**DRAFT DECISION:
PROPOSED ACCESS
ARRANGEMENT
DAMPIER TO BUNBURY
NATURAL GAS PIPELINE**

Epic Energy (WA) Transmission Pty Ltd

**INDEPENDENT GAS PIPELINES ACCESS REGULATOR
WESTERN AUSTRALIA**

21 June 2001

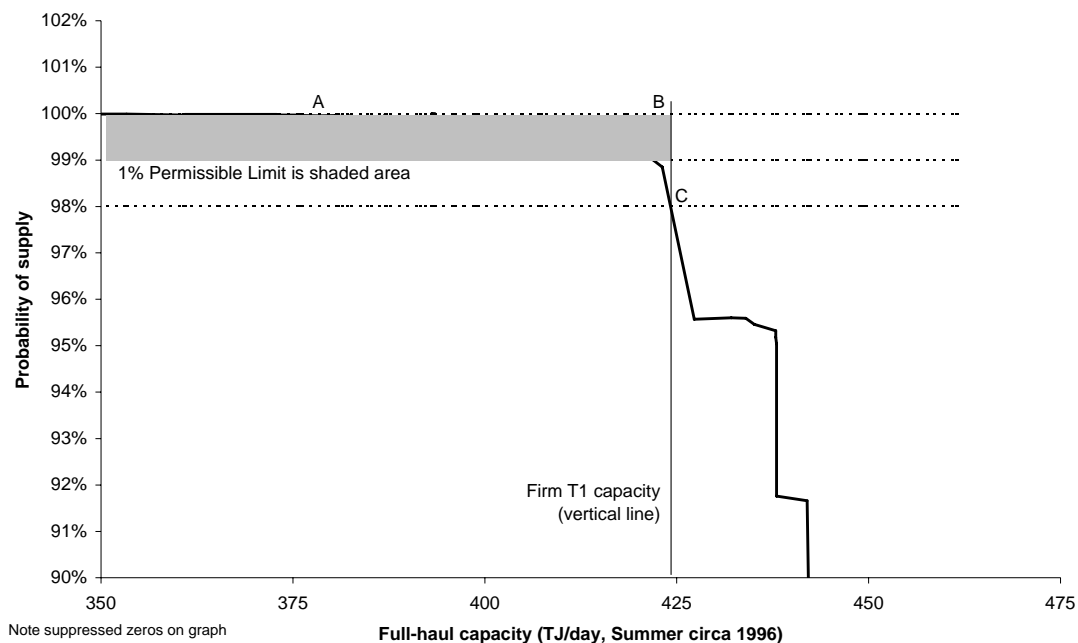
The graph [in Alintagas's Submission 3] shows the probability of supply for full-haul summer capacity on the DBNGP as the pipeline was configured around the summer of 1996. The data is from a report by Tenneco Energy International (now Epic Energy) in November 1996, titled "*A Study of the Dampier to Bunbury Natural Gas Pipeline*" (the "Tenneco Report"). The graph is a conservative one, since it shows the probability of supply without the implementation of recommendations in the Tenneco Report designed to improve the reliability of the DBNGP. AlintaGas does not have access to more up-to-date information.

The rectangular shaded area in the graph shows capacity that Epic Energy proposes may be curtailed as part of the one percent permissible limit. As the graph shows, a substantial portion of the capacity that may be curtailed can be expected to be available.

AlintaGas submits that the curtailment provisions proposed by Epic Energy are excessive and do not reflect the fair and reasonable reliability expectations for users of a "firm" service on the DBNGP. AlintaGas submits that having a one percent permissible limit will provide Epic Energy with the opportunity to sell more capacity as Firm Capacity. This can be seen from the above graph. As the vertical line is shifted to the right, more capacity becomes available, albeit capacity with a low probability of supply. Since the one percent permissible limit, as represented by the shaded area, is so generous, Epic Energy will be able to sell the less reliable capacity as firm capacity and Epic Energy will still be able to meet its contractual commitments.
